RESPONSE TO STAFF COMMENTS

TO: Hingham Conservation Commission

RE: 18 Shipyard Drive, Hingham

Please include this Response to Staff Comments with the Notice of Intent (NOI) application under review for the proposed patio project at 18 Shipyard Drive in Hingham (the Site). This submittal responds to the 4/28/26 email with comments as noted below with our response following in italic:

DRAWING NUMBER:
C-101

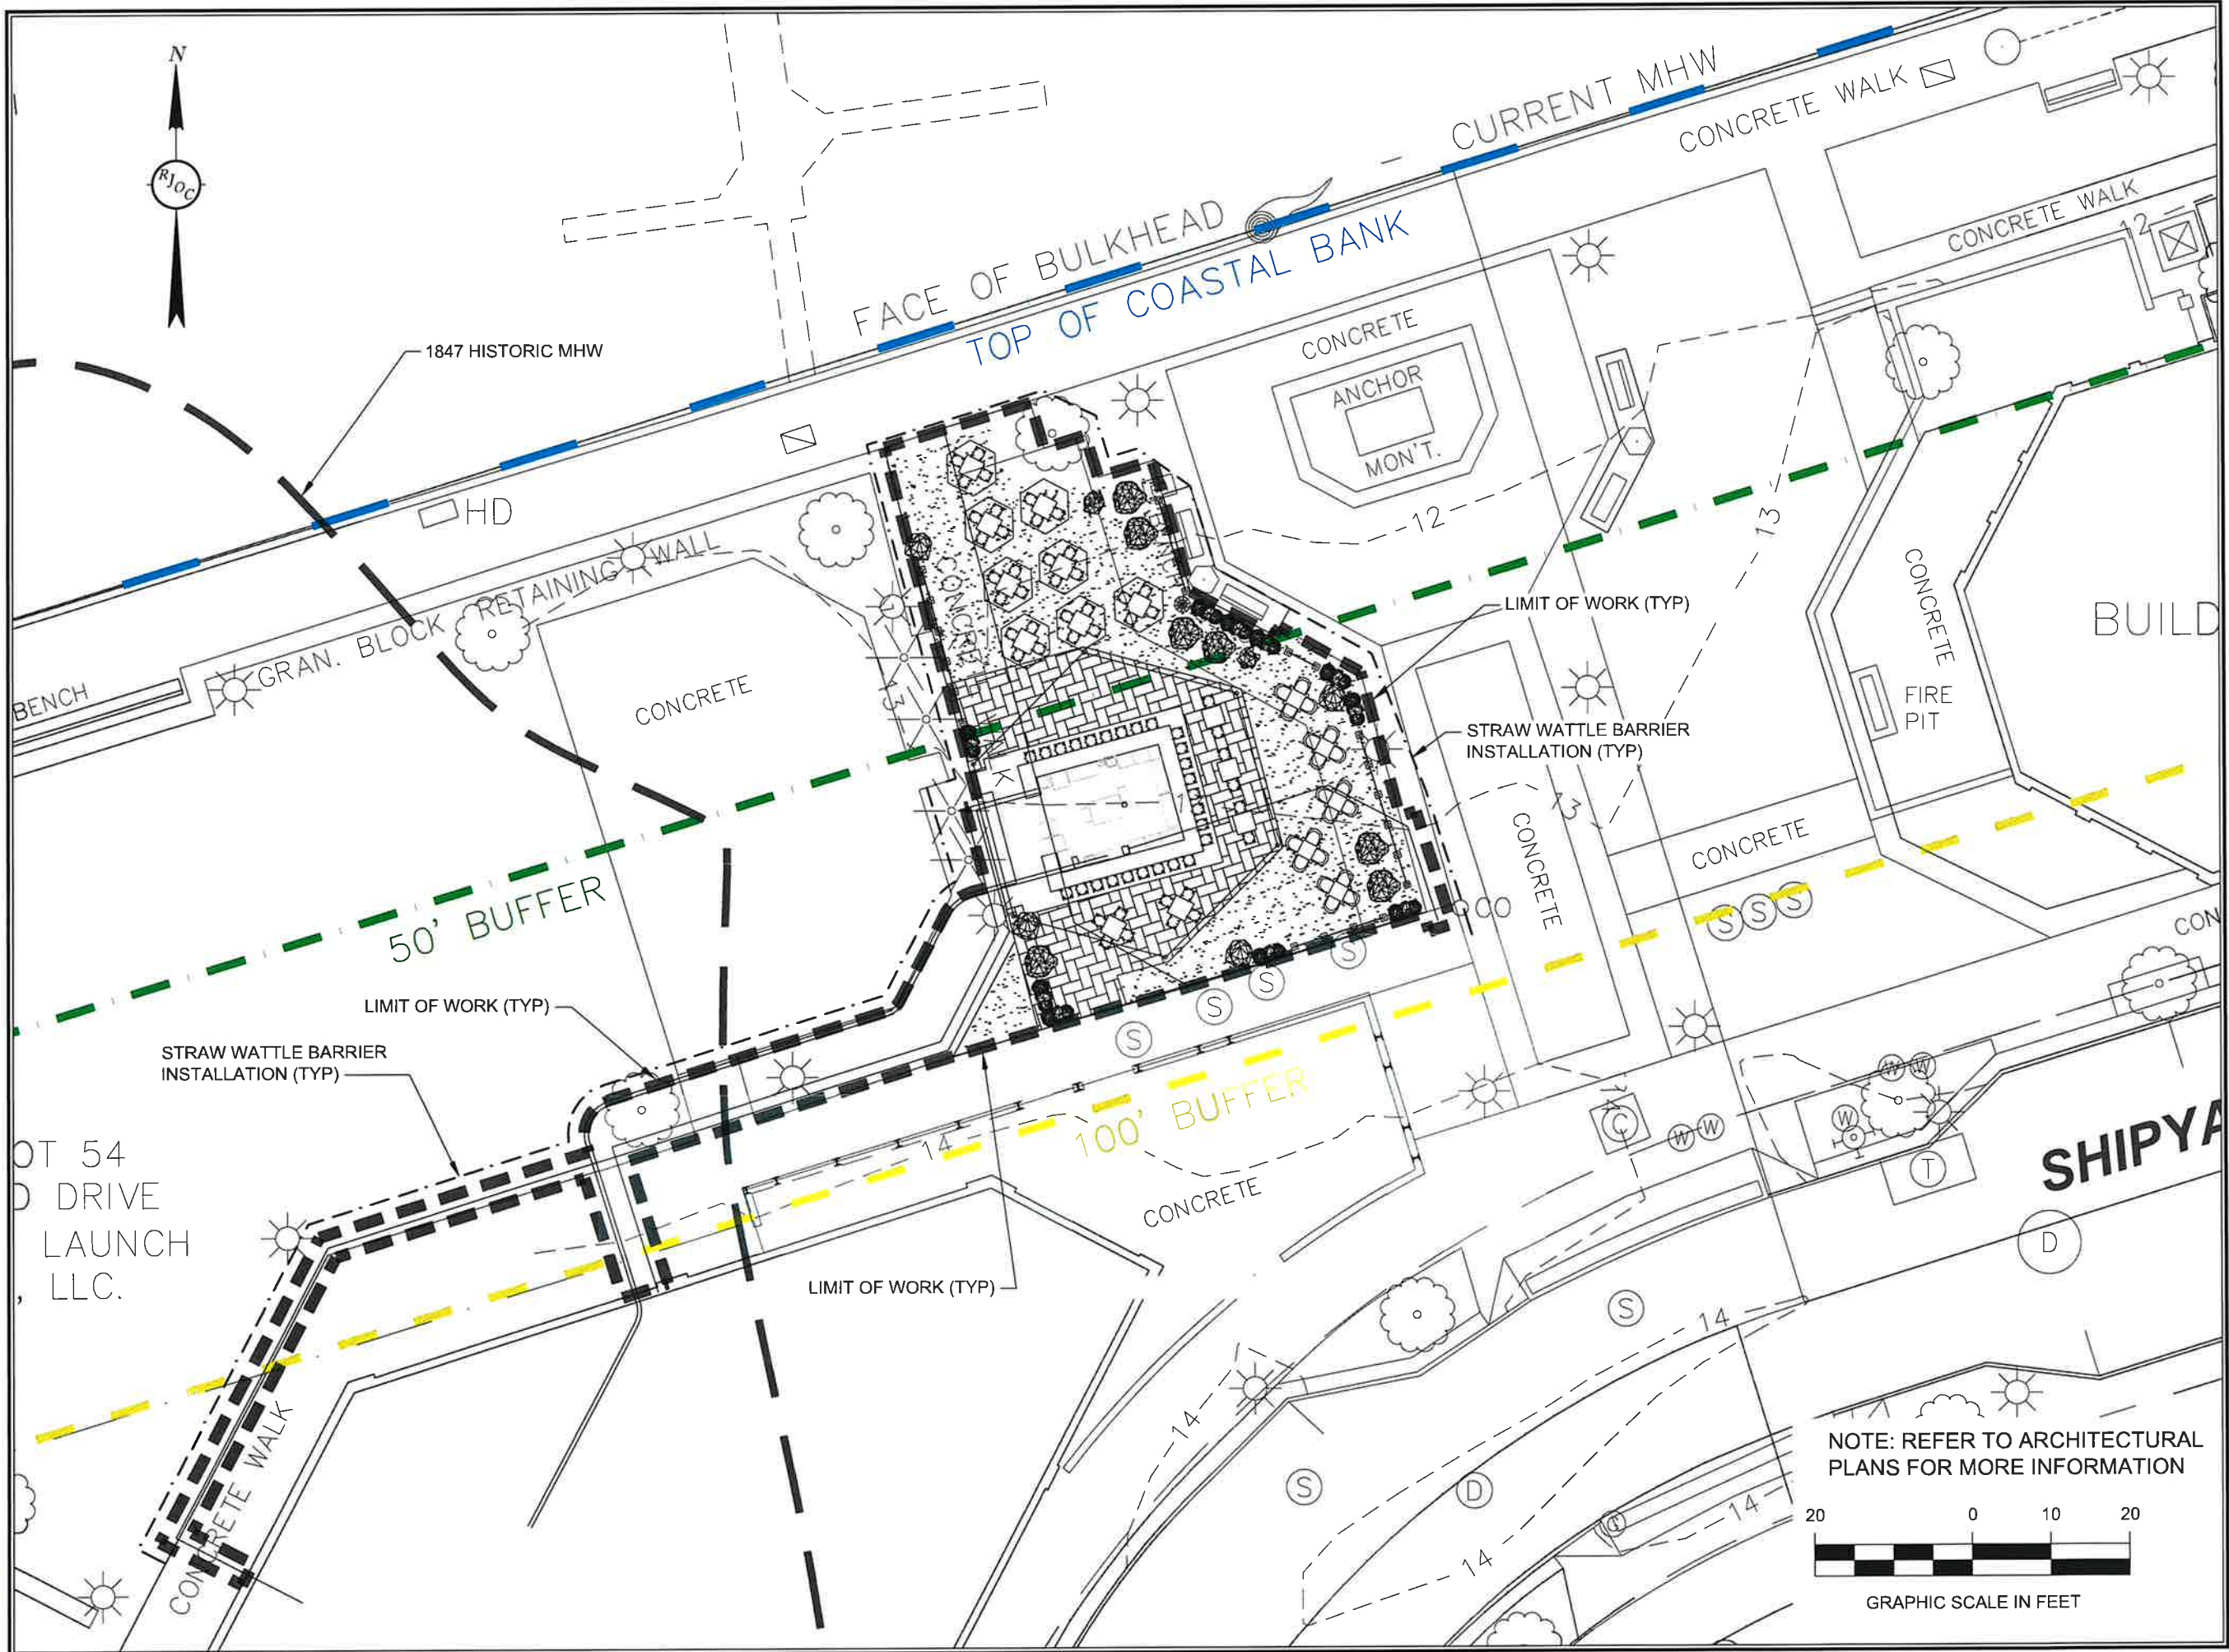
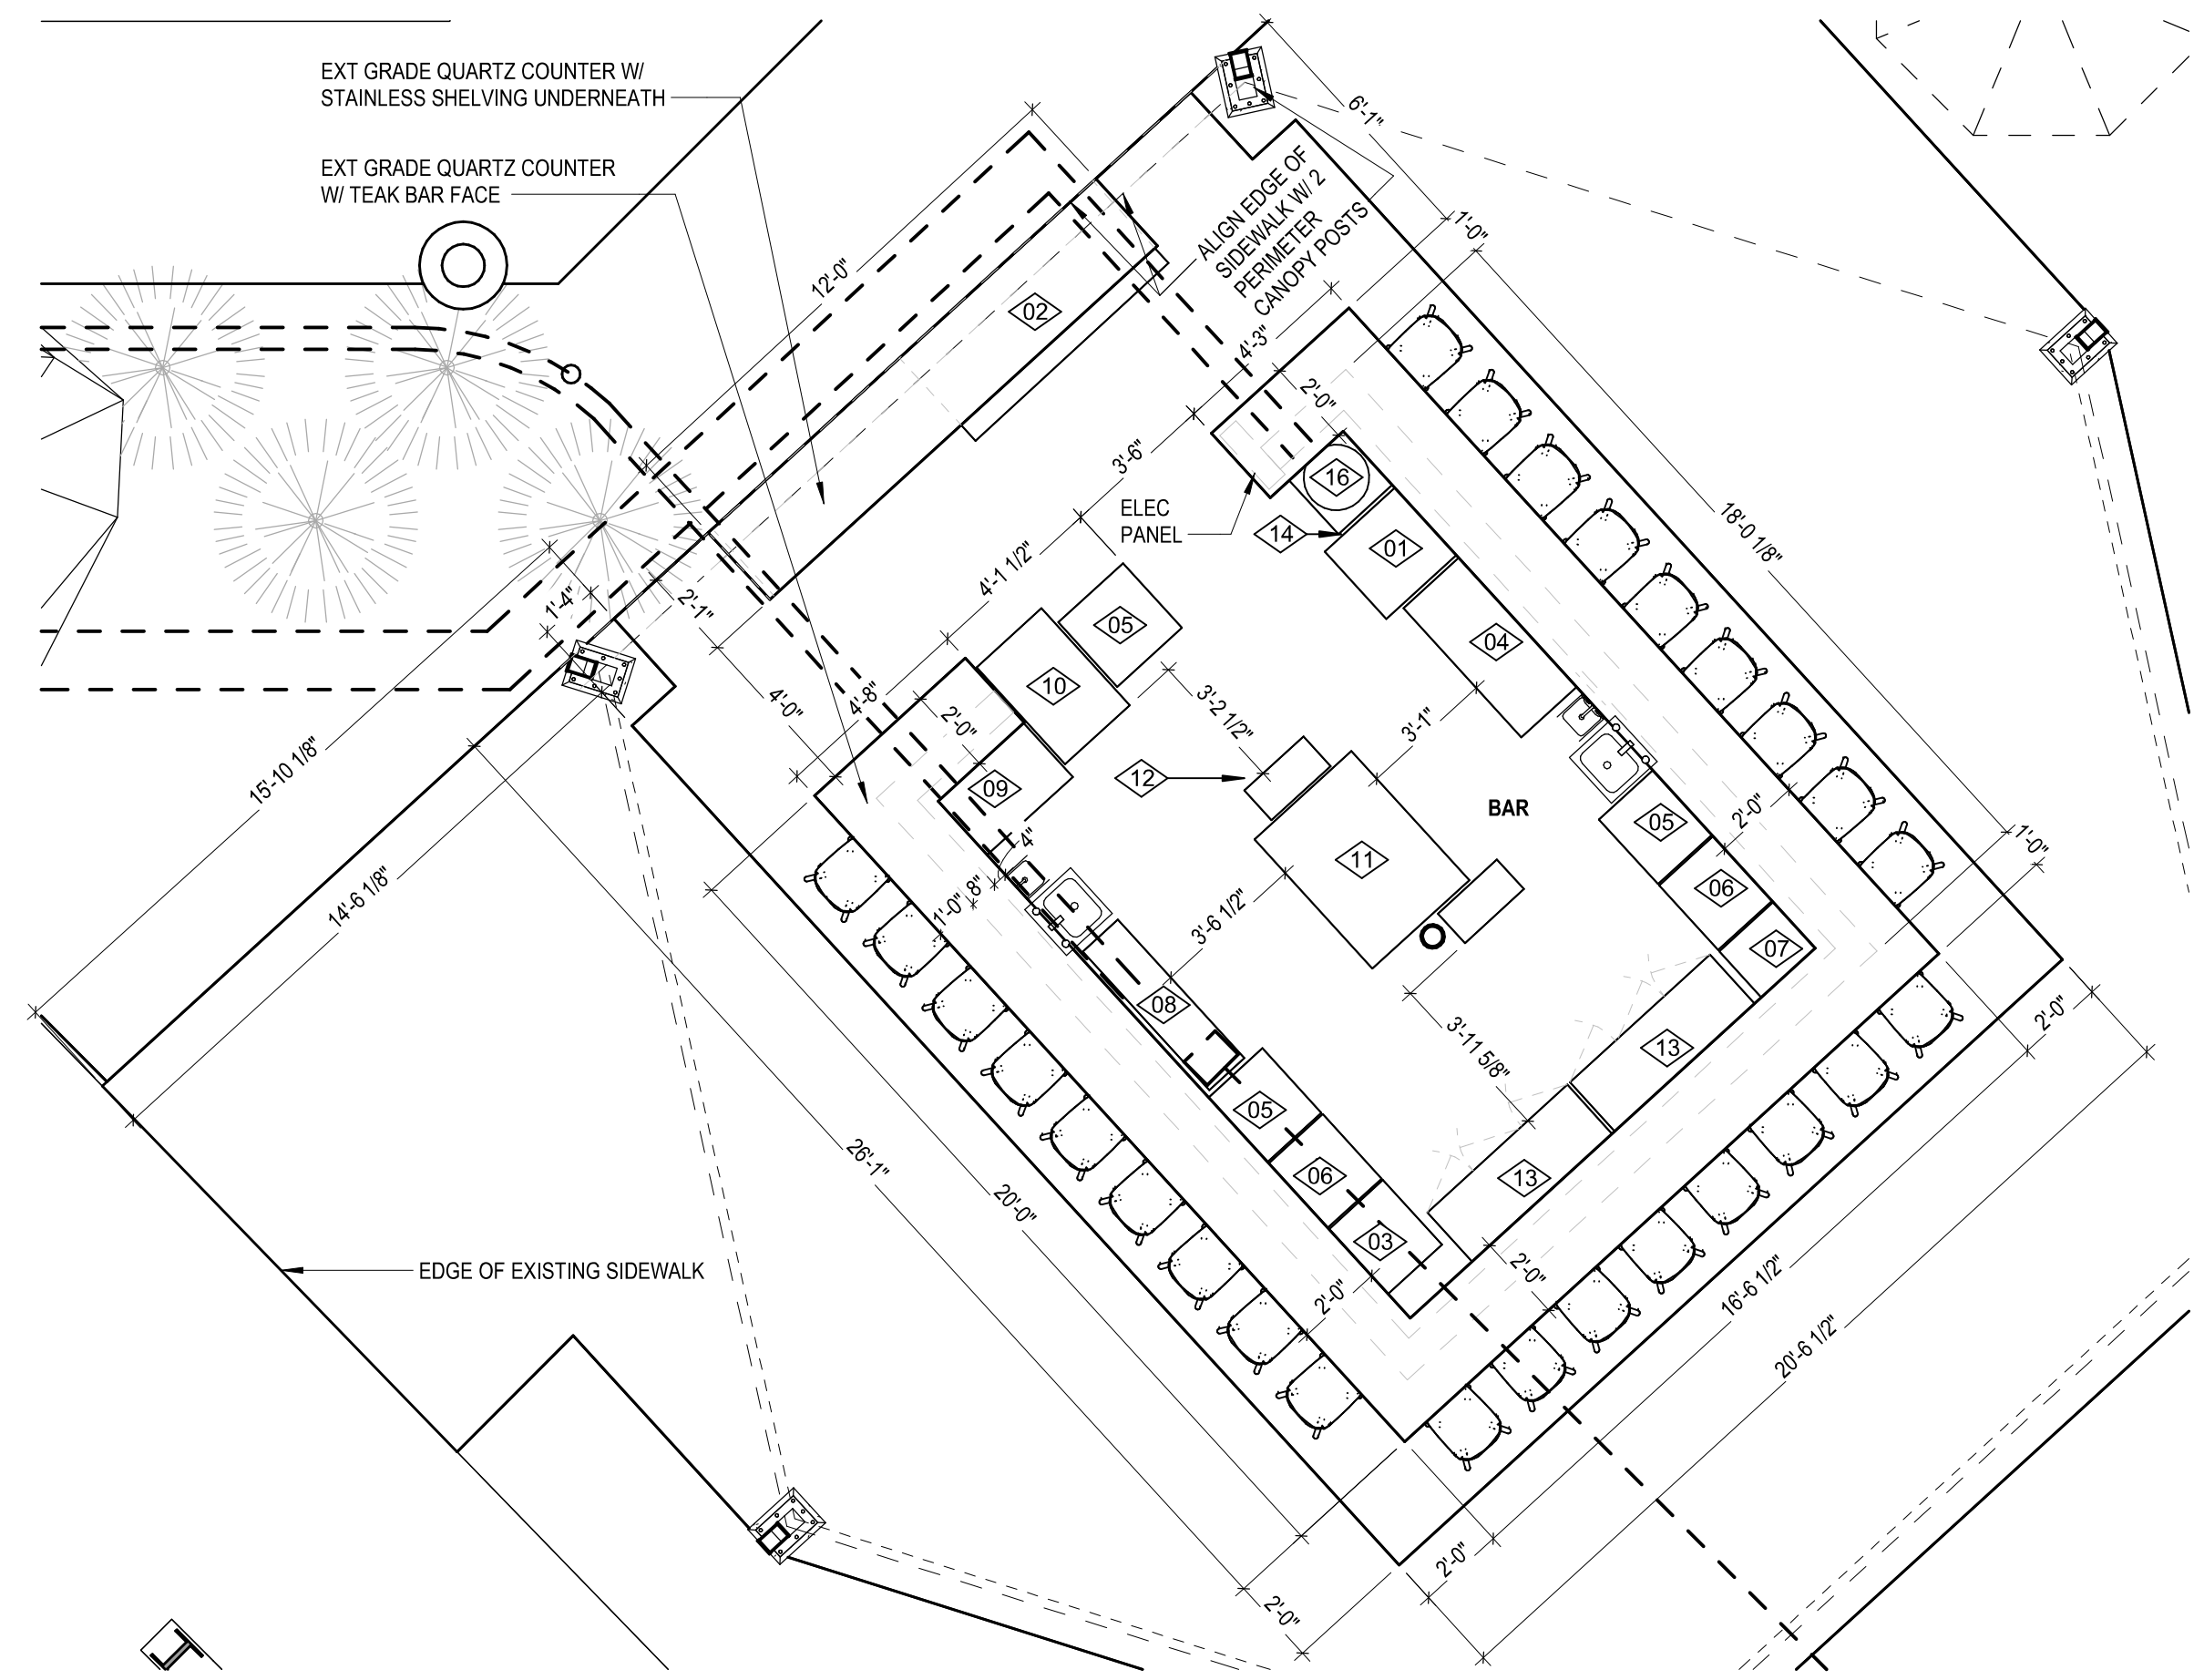
- The submitted plans are not stamped, do not meet the submittal requirements in the NOI Checklist and as stated above, are not consistent with plans submitted to the Building Dept. Please address.

Response – The previously submitted plans have been revised to include being stamped stamped by a MA Registered Professional Engineer and now meet the submittal requirements in the NOI checklist. As referenced previously, the plans submitted to the Building Department will be amended to match the plans provided as part of this NOI.
